Tech Article

TA0019: TA0019: Oil Spinner Retention

Reference	TA0019
Last Modified	2017-09-15
Models	2017: FXSB, FXSE 2018: FLFB, FLFBS, FLFBS ANV, FLFBS ANX, FXBR, FXBRS, FXBRS ANX
Category	Primary Drive
MARKETS	All markets where 2017 FXSB and FXSE models, and 2018 FLFB, FLFBS, FLFBS ANV, FLFBS ANX, FXBR, FXBRS and FXBRS ANX models are sold.
VEHICLES AFFECTED	Some 2017 FXSB, FXSE and some 2018 FLFB, FLFBS, FLFBS ANV, FLFBS ANX, FXBR, FXBRS, FXBRS ANX
AFFECTED PART	62700062
ISSUE	We have identified the potential for the oil spinner to become detached from the sprocket retainer on some 2017 and 2018 Softail motorcycles. A quality issue with the sprocket retainer has been identified as the cause.

Figure 1. Primary Drive Components

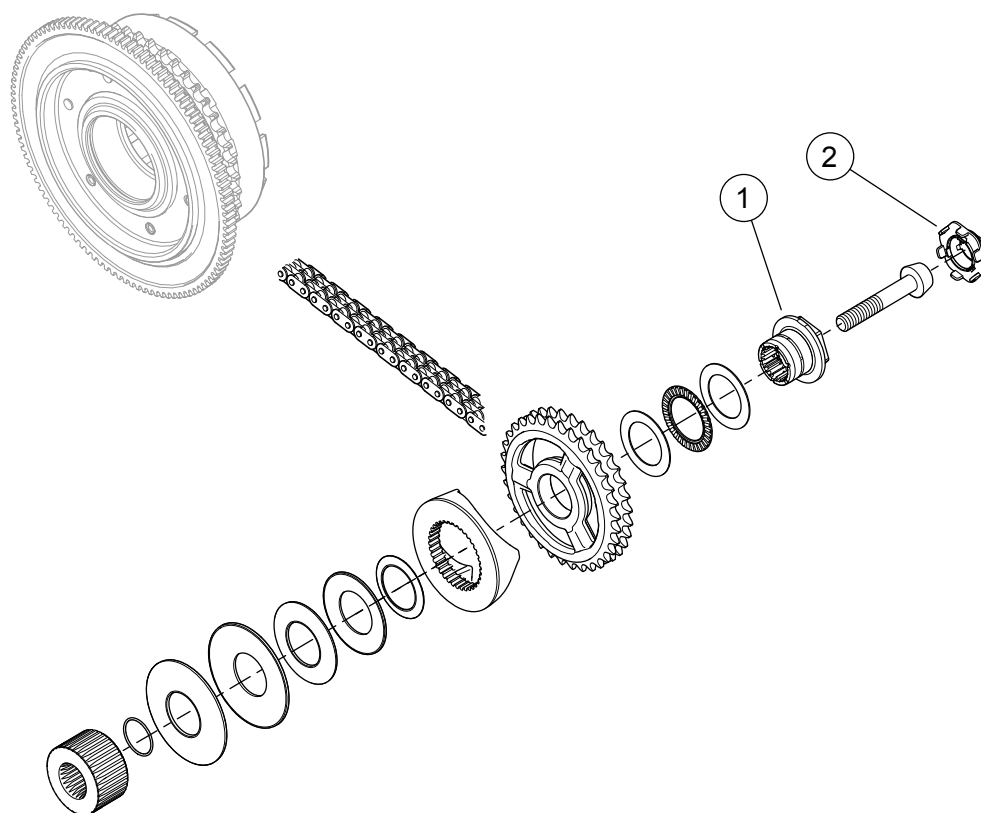
See Figure 1. The oil spinner (2) may be partially secured or separated from the sprocket retainer (1).

If you determine that an oil spinner has lost retention, inspect the compensator assembly for wear and service as needed. Upon reassembly, replace both the oil spinner and sprocket retainer.

The oil spinner retention issue has been corrected in motorcycle production starting September 1, 2017 .
